Maplewood Road  
11/11/04 to 3/23/05

RE: Arapaho Road Phase III  
Surveyor Boulevard to Addison Road  
Supplemental Agreement 13

<b>Project:</b>	Arapaho Road Phase 3 – Shop Drawing Review
<b>Client:</b>	Town of Addison, Texas
<b>Report No.:</b>	2
<b>Time Period:</b>	February 26, 2005 to April 29, 2005
<b>Prepared By:</b>	Scott Forbes, P.E.

**ARAPAHO ROAD EXTENSION**  
SURVEYOR BOULEVARD TO ADDISON ROAD  
STA 65+00 TO 70+00  
SITEWORK LAYOUT & DIMENSIONING PLAN  
TOWN OF ADDISON, TEXAS

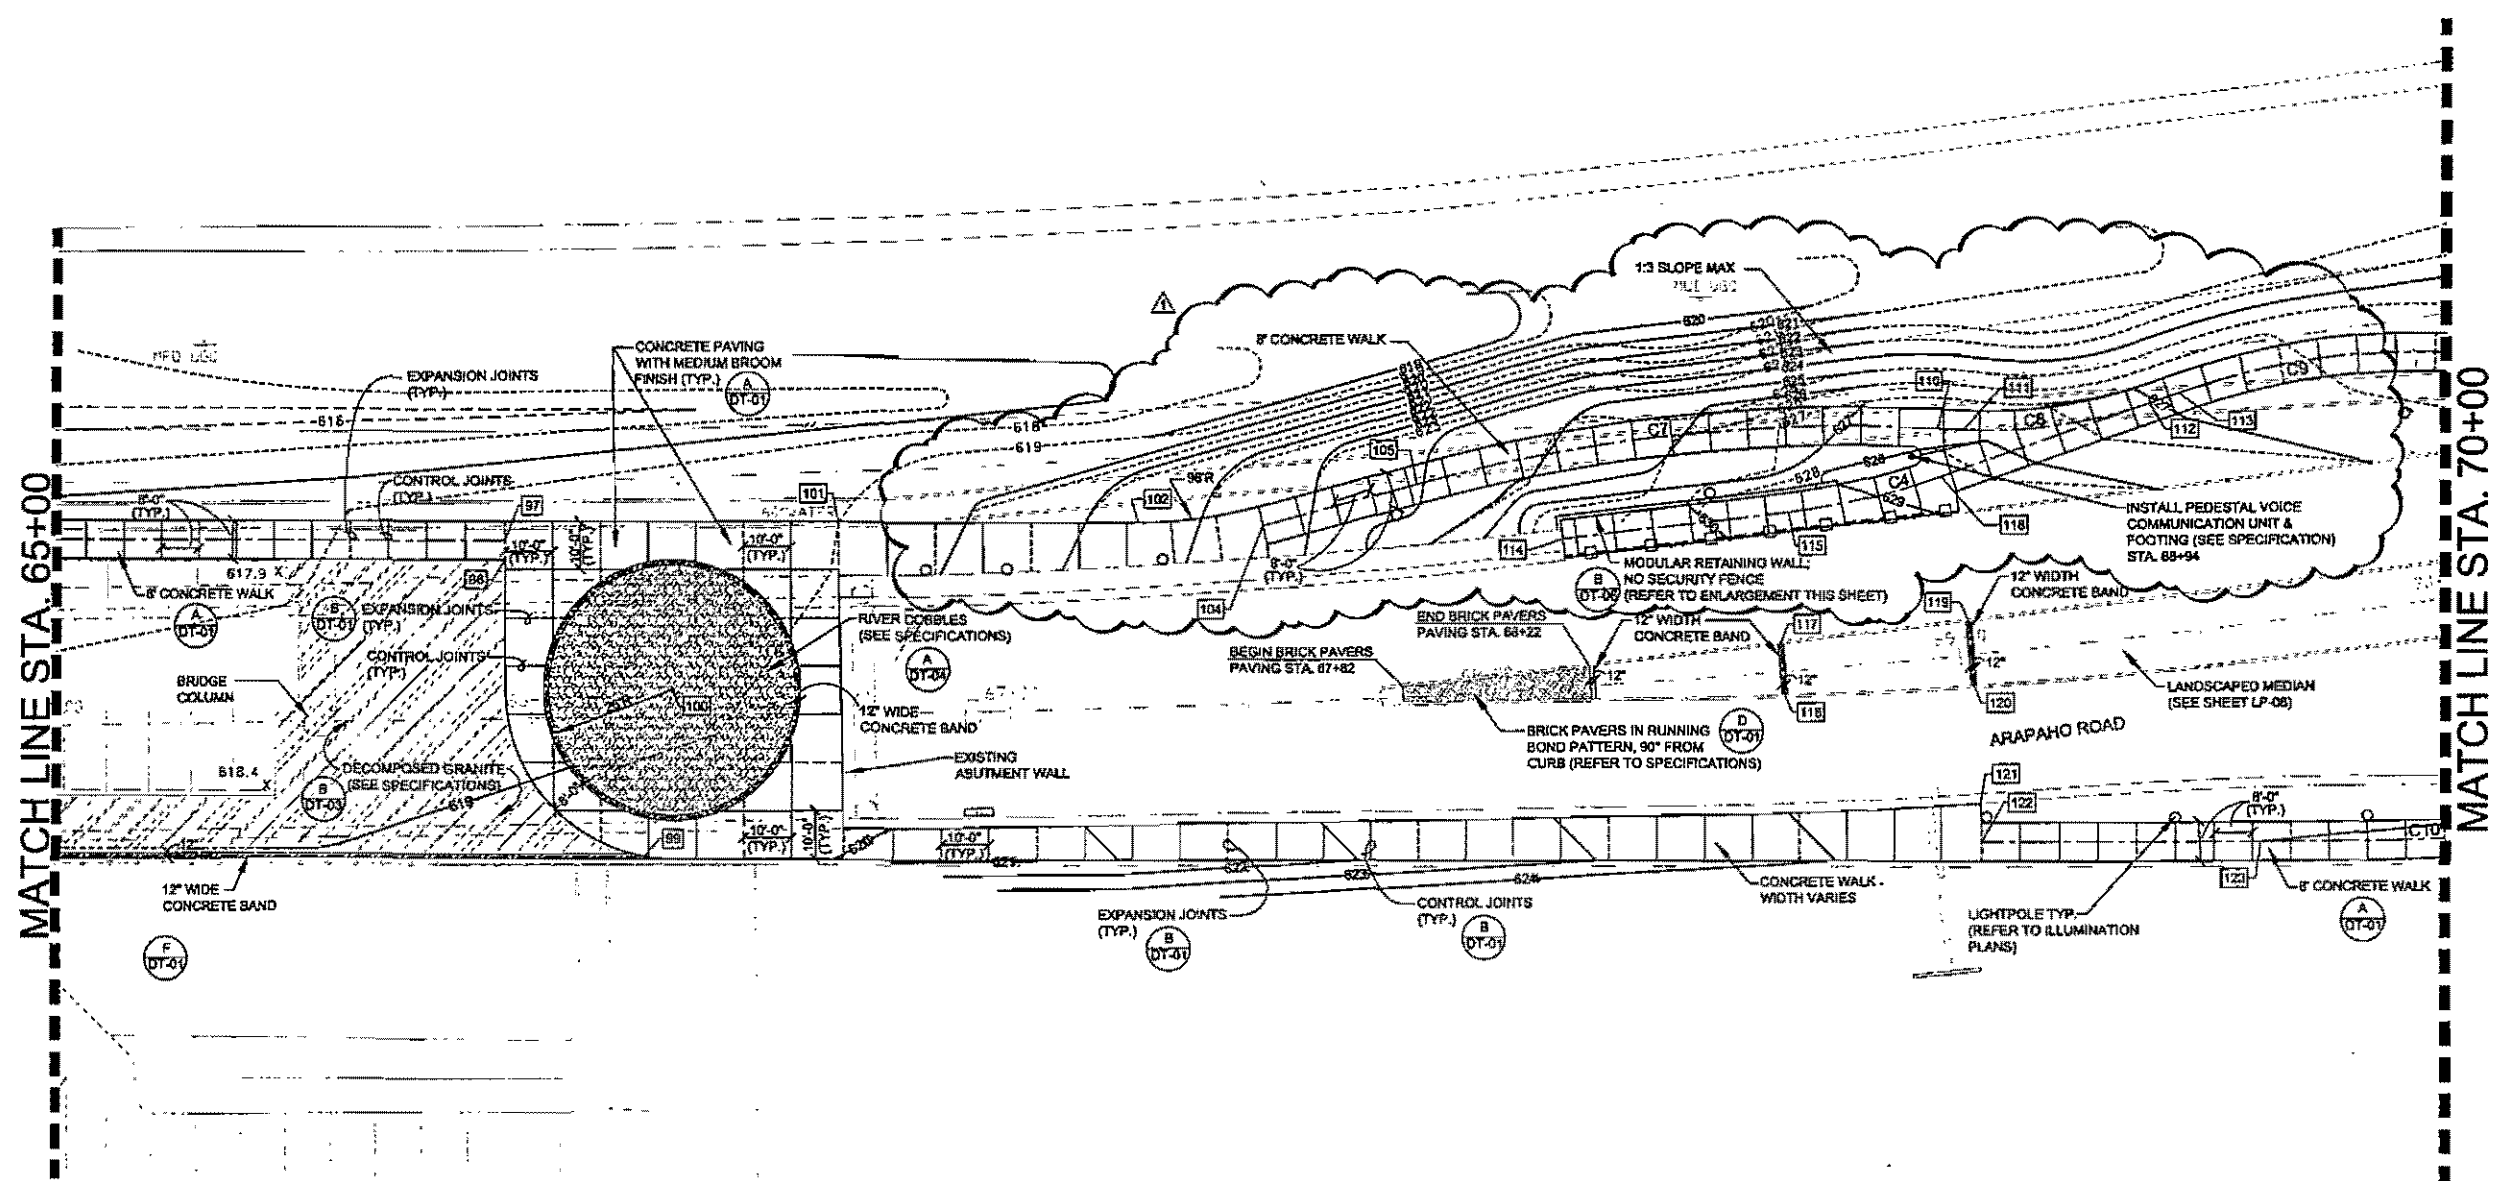
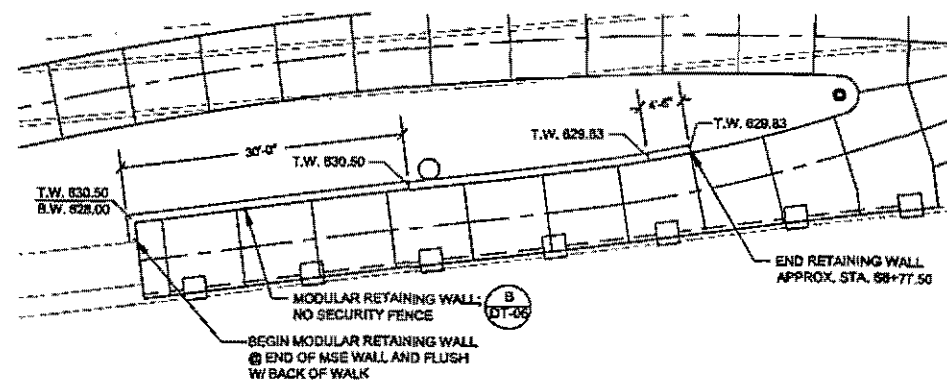
NO.	DATE	REVISION	APPROV.
1	8/28/05	REVISED CONCRETE WALK LAYOUT & GRADING	
1	8/28/05	NEW MODULAR RETAINING WALL

NO.		DATE	REVISION	APPROV.
1	6/28/05		REVISED CONCRETE WALK LAYOUT & GRADING	
1	6/28/05		NEW MODULAR RETAINING WALL

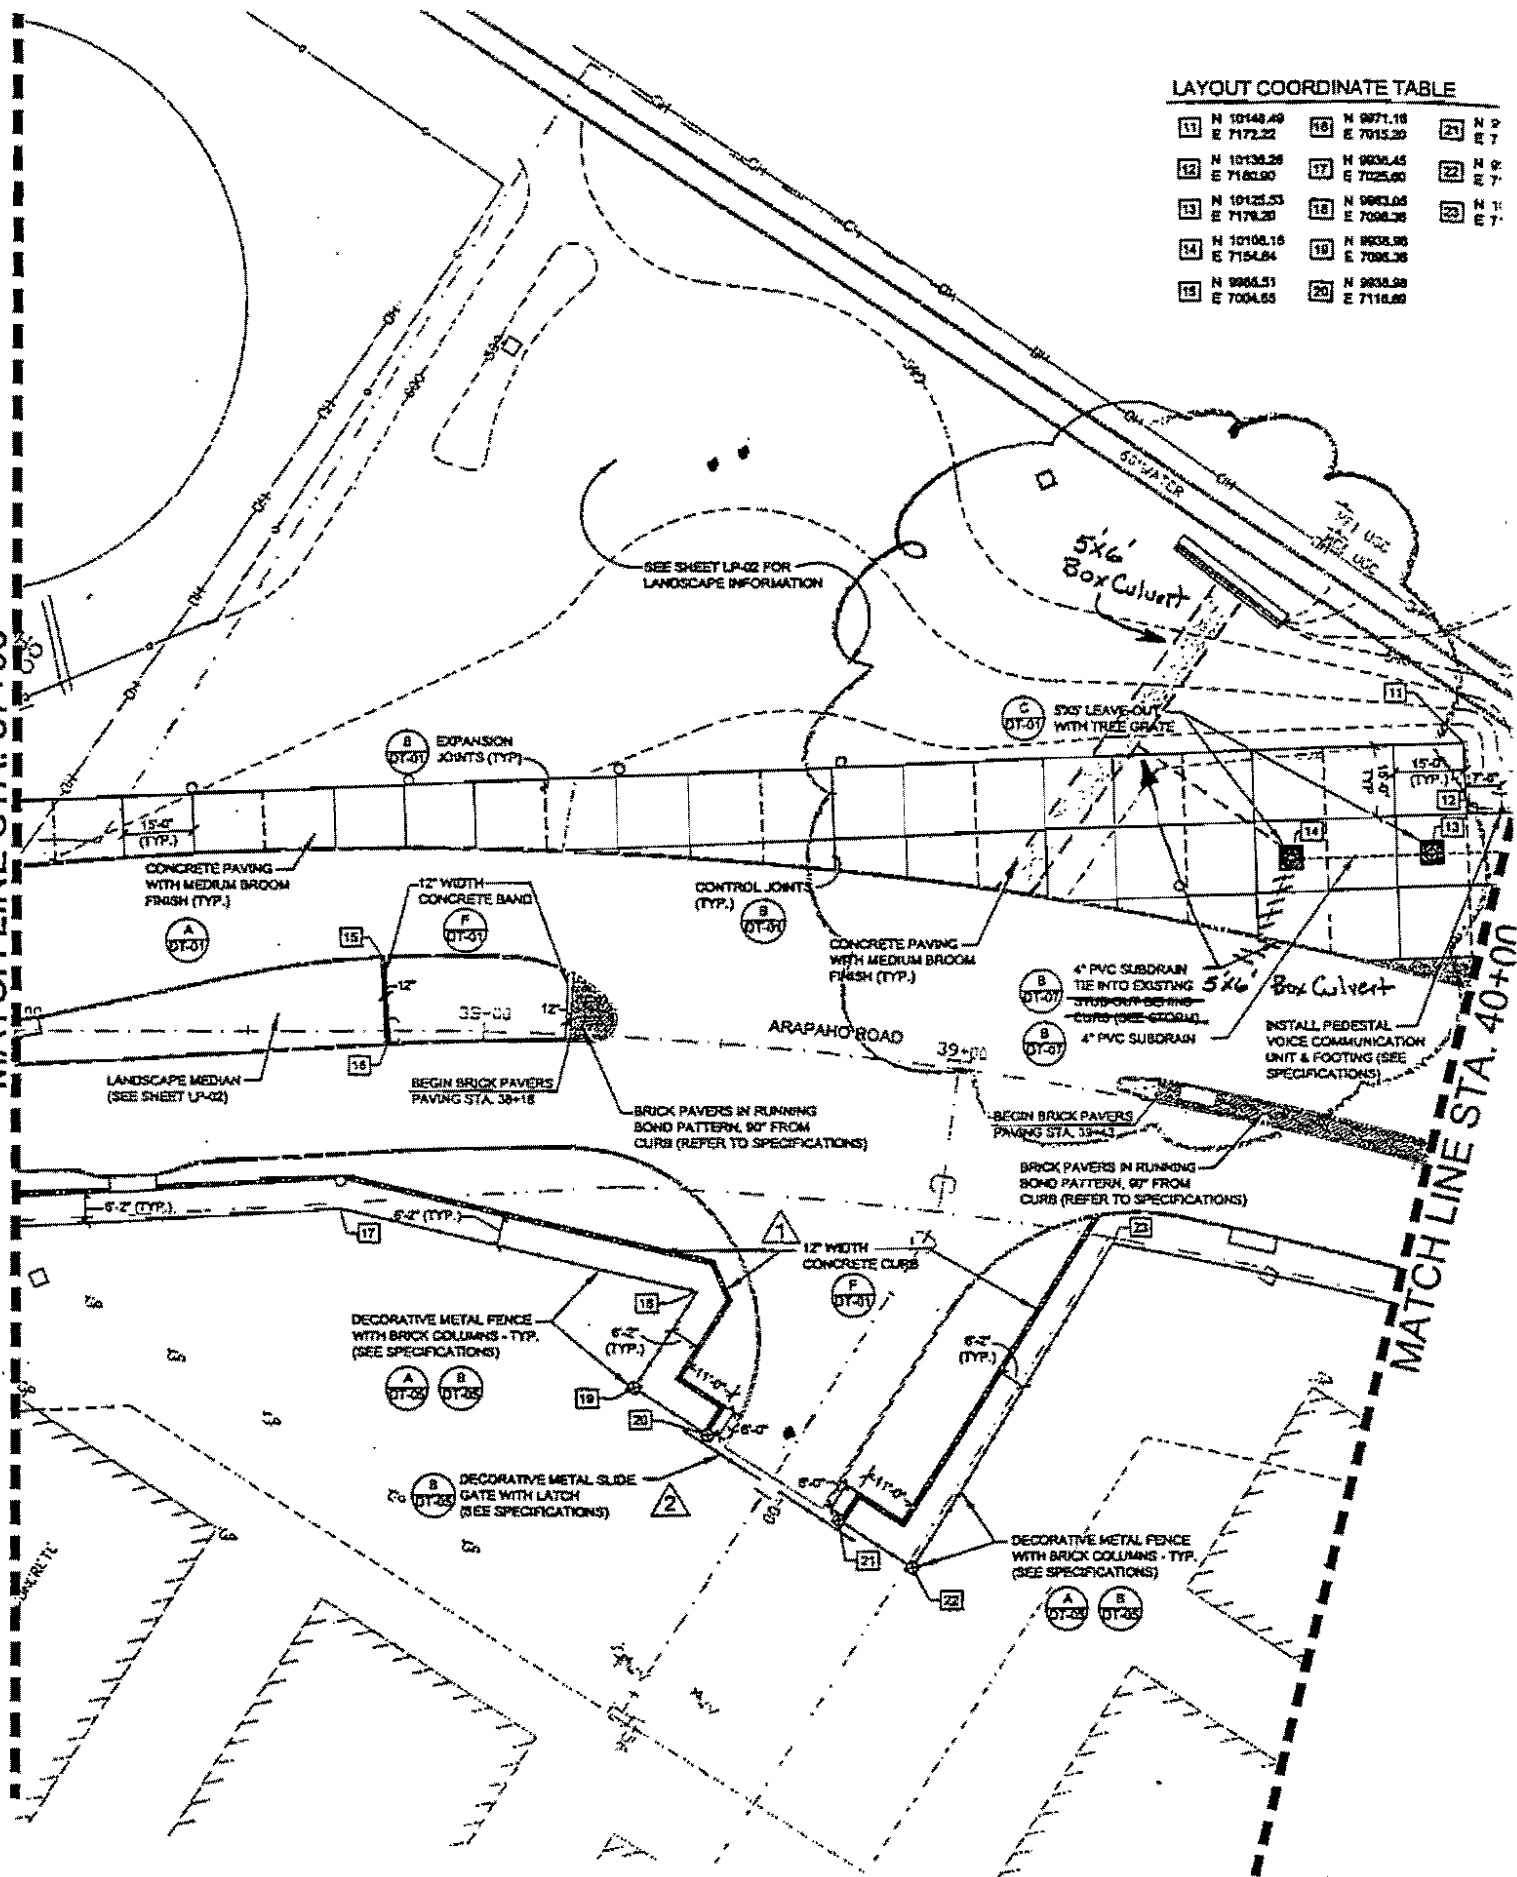
Please reference the attached sheet 189 and sheet 100

According to sheet 189, the 4" subdrain for the 3 tree wells locates in the sidewalk from Sta 39+60 to 40+20 shows to terminate into existing stub out behind curb (see Storm). Sheet 100; the line B storm sewer drawings does not show any stubs outs or inlets in this area.

The 4" PVC Tree subdrain is to tie-in to the newly installed 5'x 6' concrete box culvert just West of the last tree. The 4" subdrain shall be installed at a min. 1% slope and tie-in at the upper 2ft of the sidewall of the concrete box culvert to allow for proper drainage of the tree wells. See attached plan sketch SK-1.
